# Peshastin Irrigation District Pump Exchange Project, ~~Conceptual~~ Preliminary Design

*Chelan County Natural Resources Department  
411 Washington St. Suite 201, Wenatchee, Washington 98801  
Mike Kaputa - Director, (509) 667-6533, Mike.Kaputa@CO.CHELAN.WA.US  
PRISM #16-1787*

## RTT Comments and Applicant Responses

**Figure 3**

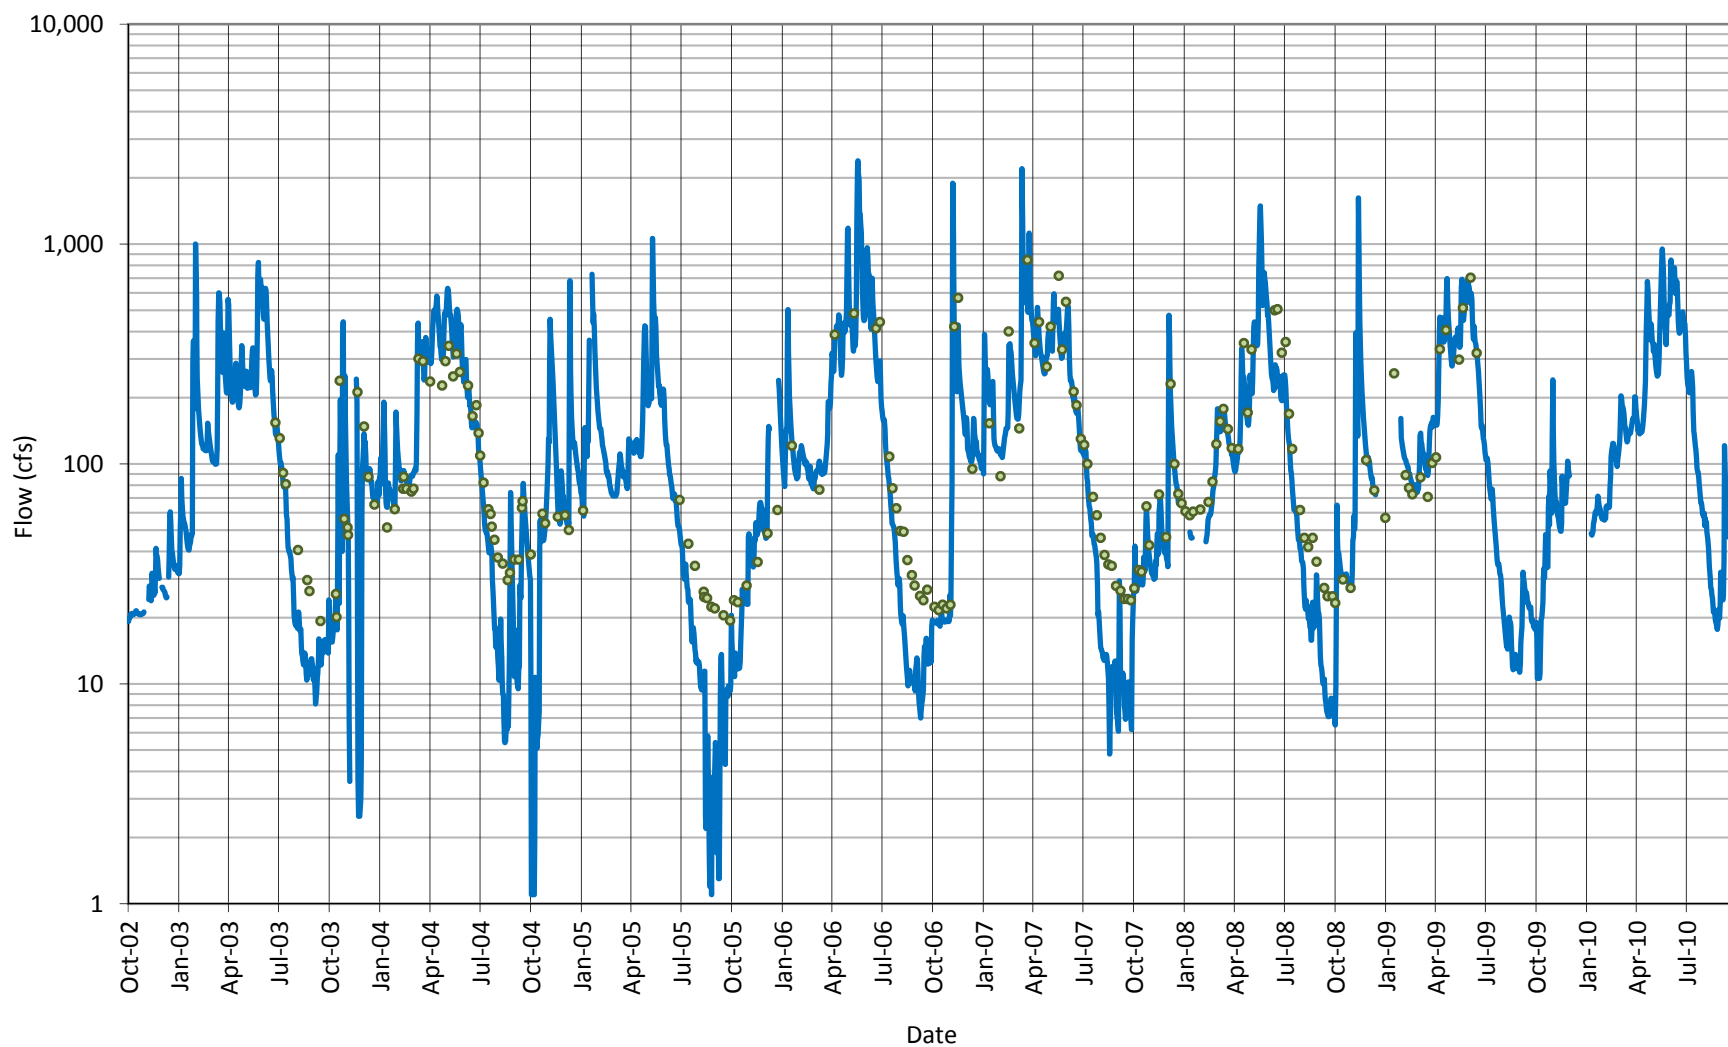
Casey – run that data through hydrograph to show how often that will happen, when it will happen in drier years, gives more operational certainty.

Response: See previous responses. Additional hydropgraph data is provided with the revised proposal.

- Figures 3 and 4 were added to provide additional background about the hydrology in Peshastin Creek.
- Reference to "conceptual" design were changed to "preliminary" design because the intent is to carry the design forward to the 30% complete stage.
